SERVICE AND APPLICATION NOTES

October 10, 2011
Re-issued 11-29-2011
H-11-05

SLP98DFV Units Failure To Calibrate Code 228

FIGURE 1

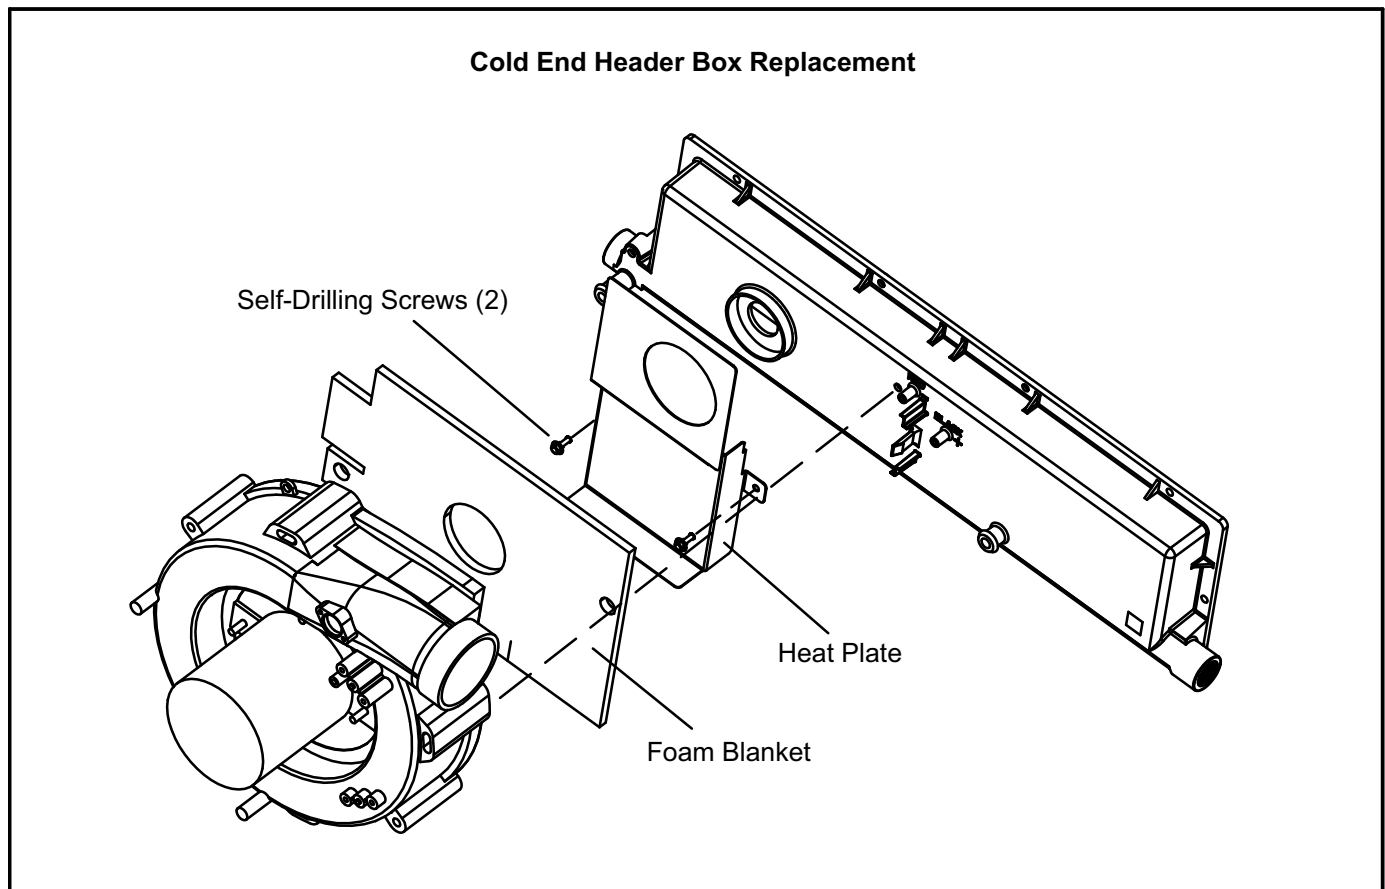
We have received reports of SLP98DFV units displaying code 228 (Failure to Calibrate). If after verifying the unit set up, drainage, and vent pipe sizing, according to specifications in the unit installation instructions, continues to give a 228 code, we are recommending replacement of the cold end header box and pressure switch on these units. See Table 1 for catalog numbers. These parts will be ordered under normal warranty terms. The cold end header box replacement kit includes a heat plate, foam blanket and self drilling screws. See figure 1 for cold end header box and figure 2 for pressure switch replacement.
